Model 114 Service Letter Index (Cont)

SERVICE LETTER NO. SL-114-1A

CABIN NOISE REDUCTION

Figure 1.

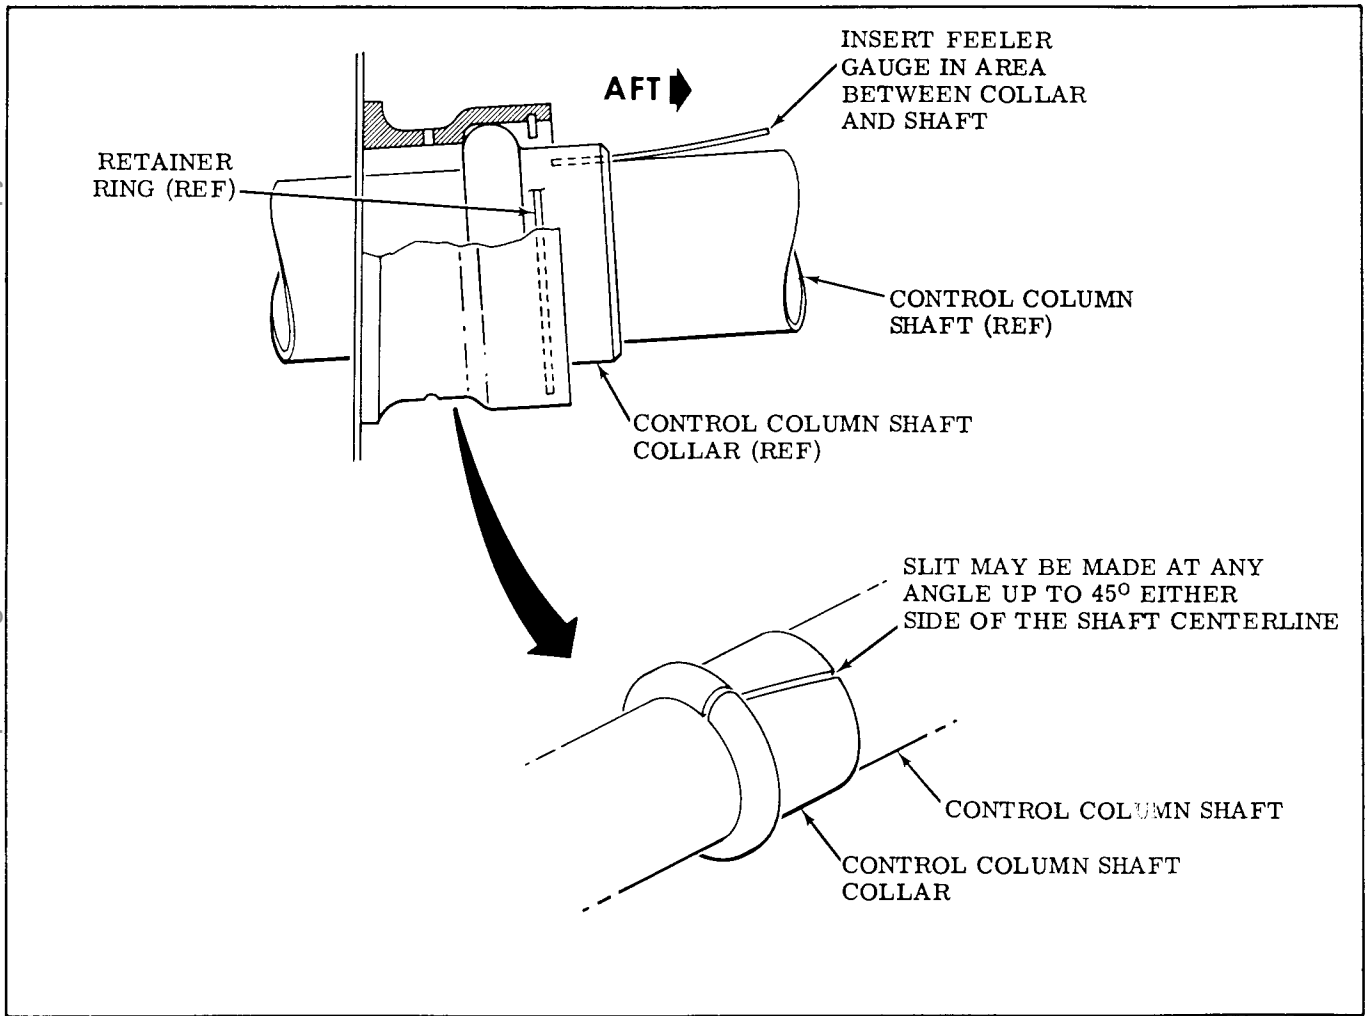
- d. Cut a slit in collar with a hacksaw blade or equivalent cutting tool. Maximum width of cut to be 0.050-inch (see Figure 1.).

Figure 1.

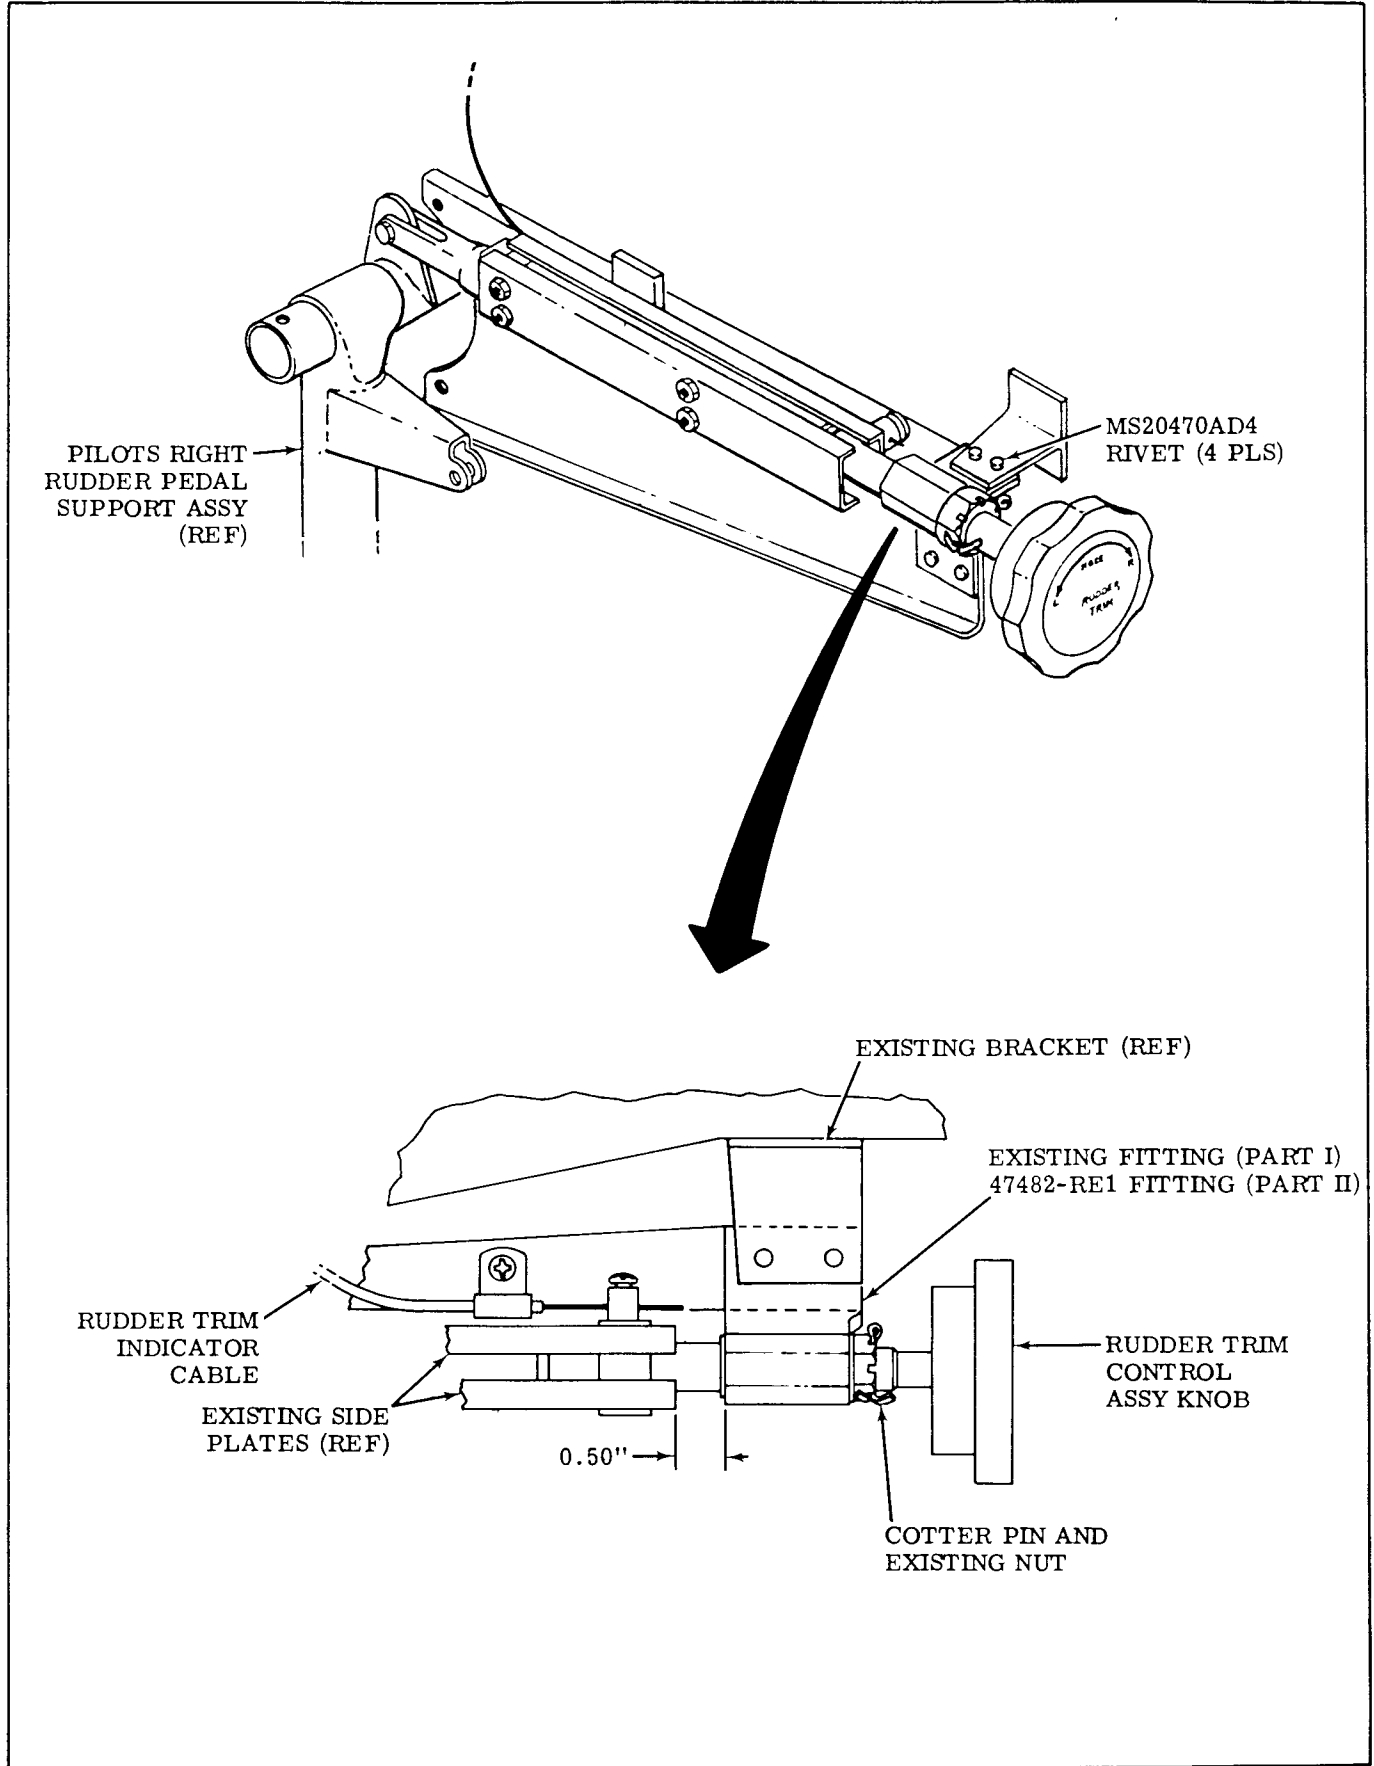
1. Remove cotter pin from existing nut on rudder trim control assembly shaft and back nut off threads (see Figure 1.).
2. Turn rudder trim control assembly knob counterclockwise until stop is contacted and then turn control knob clockwise exactly six (6) complete turns and clamp a stiff straight edge to pilot's rudder pedals.

3. Check for 0.50 (\pm 0.03) inch dimension between rudder trim control assembly fitting and side plate (see Figure 1.).
4. If dimension between rudder trim control assembly fitting and side plate exceeds 0.53-inch, remove straight edge from pilot's rudder pedals and proceed to Part II.
5. If dimension between rudder trim control assembly fitting and side plate is 0.50 (\pm 0.03) inch, remove straight edge from pilot's rudder pedals.
6. Remove rudder trim control assembly knob and nut, loosened in step 1., from shaft.
7. Disconnect forward shaft of rudder trim control assembly from top of pilot's right rudder pedal support assembly.
8. Disconnect rudder trim indicator cable from rudder trim control assembly and remove rudder trim control assembly from airplane.
9. Disassemble rudder trim control assembly and discard existing springs.

10. Turn rudder trim control assembly knob counterclockwise until stop is contacted and then turn control knob clockwise exactly six (6) complete turns and clamp a stiff straight edge to pilot's rudder pedals.
11. Position 47482-RE1 fitting on rudder trim control assembly shaft to 0.50 (\pm 0.03) inch dimension shown in Figure 1. and clamp fitting to rudder trim control assembly bracket.

12. Drill and install 47482-RE1 fitting on rudder trim control assembly bracket with MS20470AD4 rivets (4 places) (see Figure 1.).
13. Reinstall existing nut and cotter pin on rudder trim control assembly shaft.
14. Reconnect rudder trim indicator cable to rudder trim control assembly.
15. Check rudder trim indicator rigging as outlined in the Airplane Maintenance Manual, Section VII.
16. Proceed to RECORD COMPLIANCE.

Figure 2.

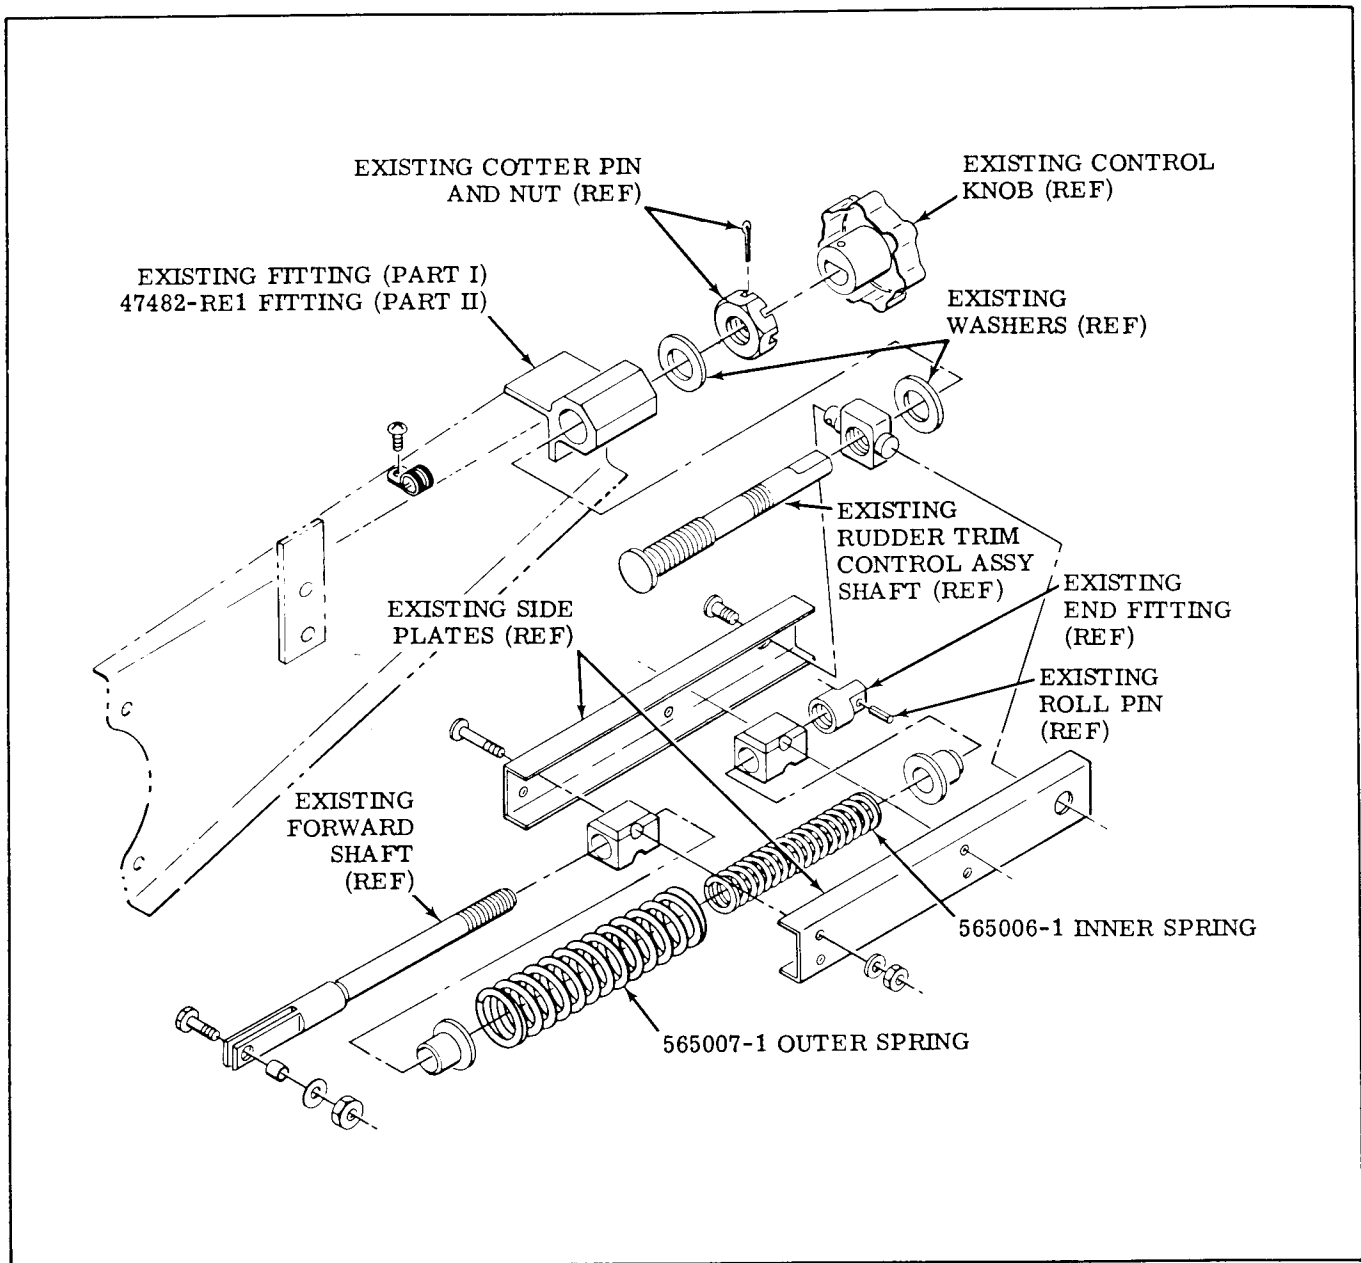
10. Install new 565006-1 inner spring and 565007-1 outer spring and reassemble rudder trim control assembly (see Figure 2.).
11. Reinstall rudder trim control assembly in airplane using existing hardware.
12. Reinstall existing washers, nut and cotter pin, removed in step 1., and rudder trim control assembly knob (see Figure 2.).
13. Reconnect rudder trim indicator cable to rudder trim control assembly.
14. Check rudder trim indicator rigging as outlined in the Airplane Maintenance Manual, Section VII.
15. Proceed to RECORD COMPLIANCE.

5. Install new 565006-1 inner spring and 565007-1 outer spring and reassemble rudder trim control assembly (see Figure 2.).
6. Remove and discard existing fitting from rudder trim control assembly bracket (see Figure 2.).

Figure 1.

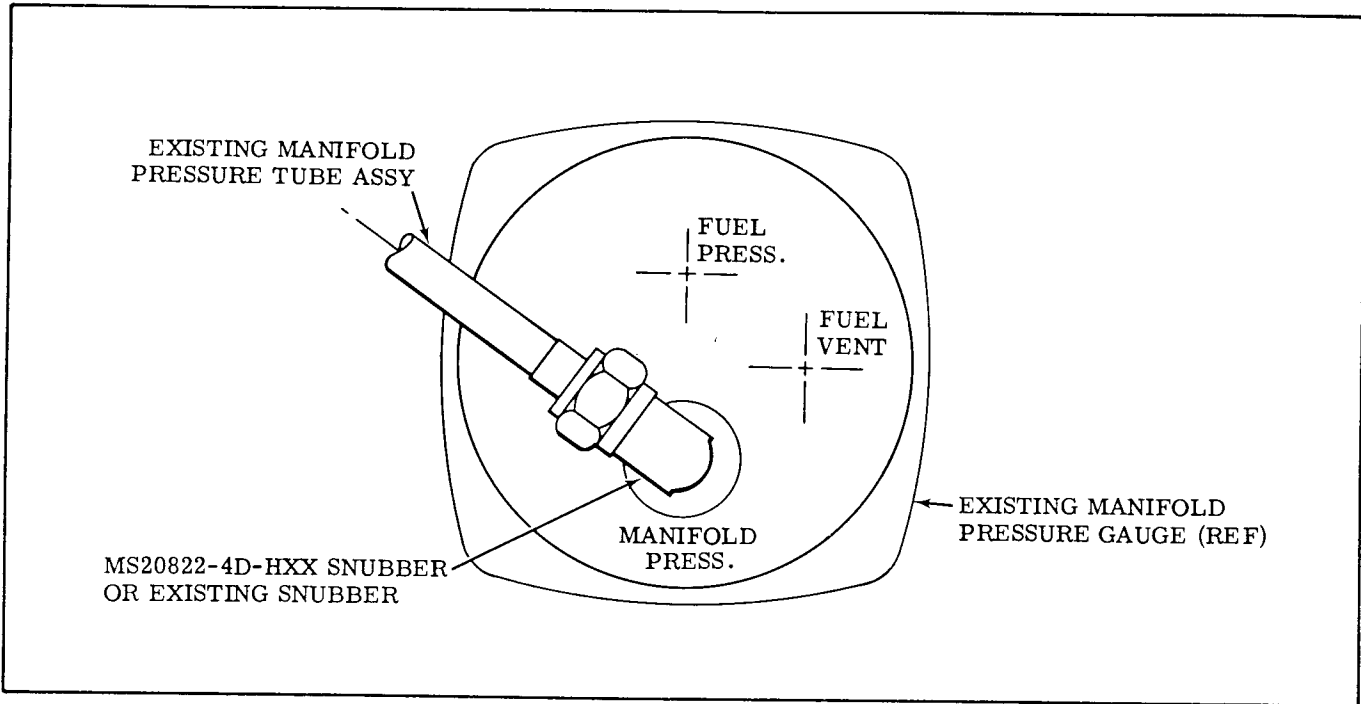
1. Disconnect manifold pressure tube assembly from existing fitting in manifold pressure gauge port (see Figure 1.).
2. Remove and disconnect existing manifold pressure gauge fitting.
3. Remove and discard Phillips head dampening screw located inside manifold pressure port of manifold pressure gauge.

5. Install MS20822-4D-HXX pressure snubber in manifold pressure gauge (see Figure 1.).
6. Connect existing manifold pressure tube assembly to pressure snubber (see Figure 1.).
7. Fill out and mail Compliance Card and proceed to RECORD COMPLIANCE.

1. Disconnect manifold pressure tube assembly from existing pressure snubber in manifold pressure gauge port (see Figure 1.).
2. Remove existing pressure snubber from manifold pressure gauge.
3. Remove and discard Phillips head dampening screw (if installed) located inside manifold pressure port of manifold pressure gauge.

5. Install existing pressure snubber in manifold pressure gauge (see Figure 1.).
6. Reconnect existing manifold pressure tube assembly to existing pressure snubber (see Figure 1.).
7. Fill out and mail Compliance Card.

Figure 1.

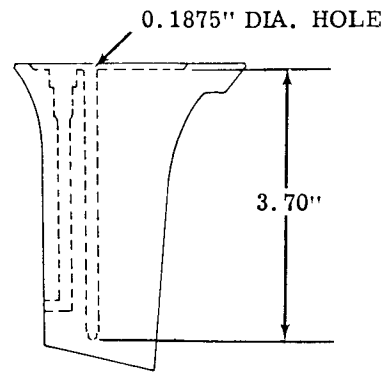
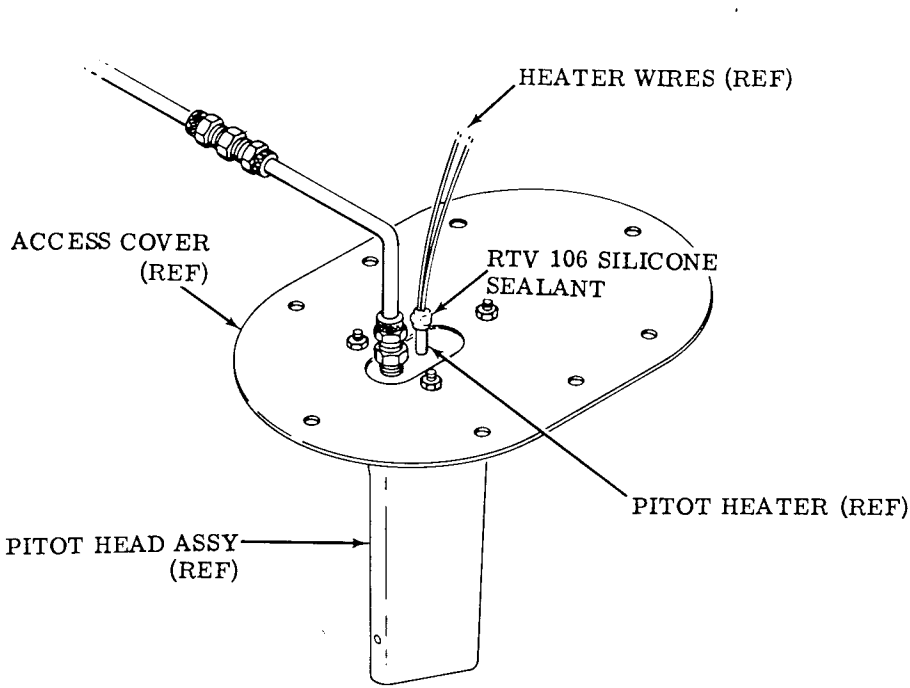
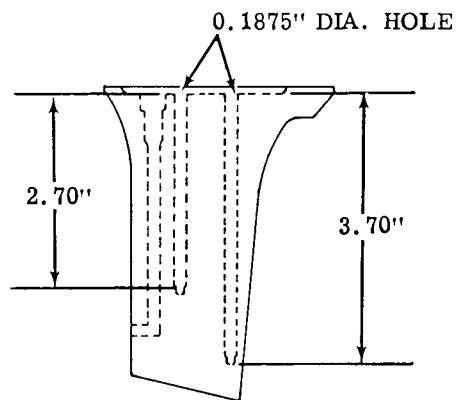
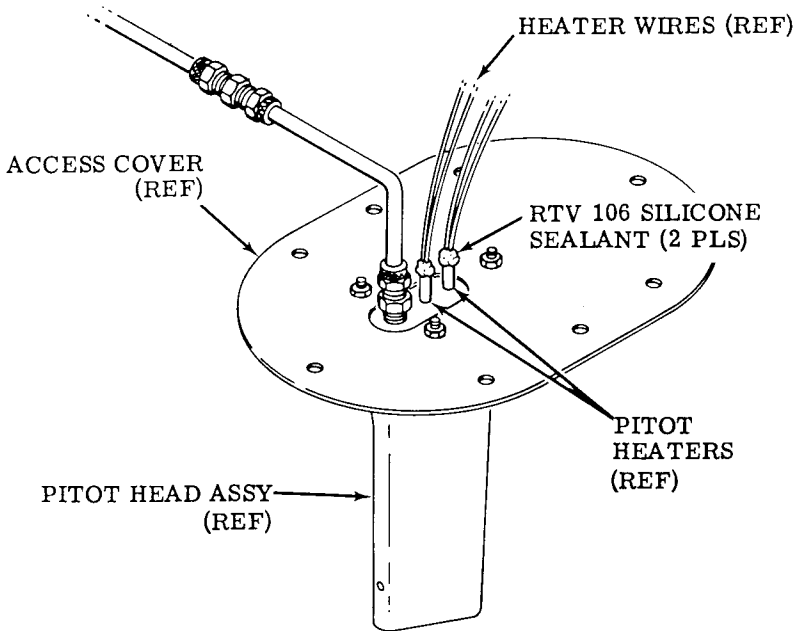
1. Remove screws attaching pitot head assembly access cover to wing and pull down on pitot head assembly.
2. Check dimension from top of pitot heater(s) to top of pitot head assembly to assure that pitot heater(s) is installed properly in pitot head assembly. Dimension should be 0.375-inch to 0.50-inch (see Figure 1.).

- a. Remove pitot heater(s) from pitot head assembly.
 - b. Ream 0.1875-inch diameter hole(s) to depth specified in Figure 1.
 - c. Inspect pitot heater wires for possible fraying of insulation or bare wires.
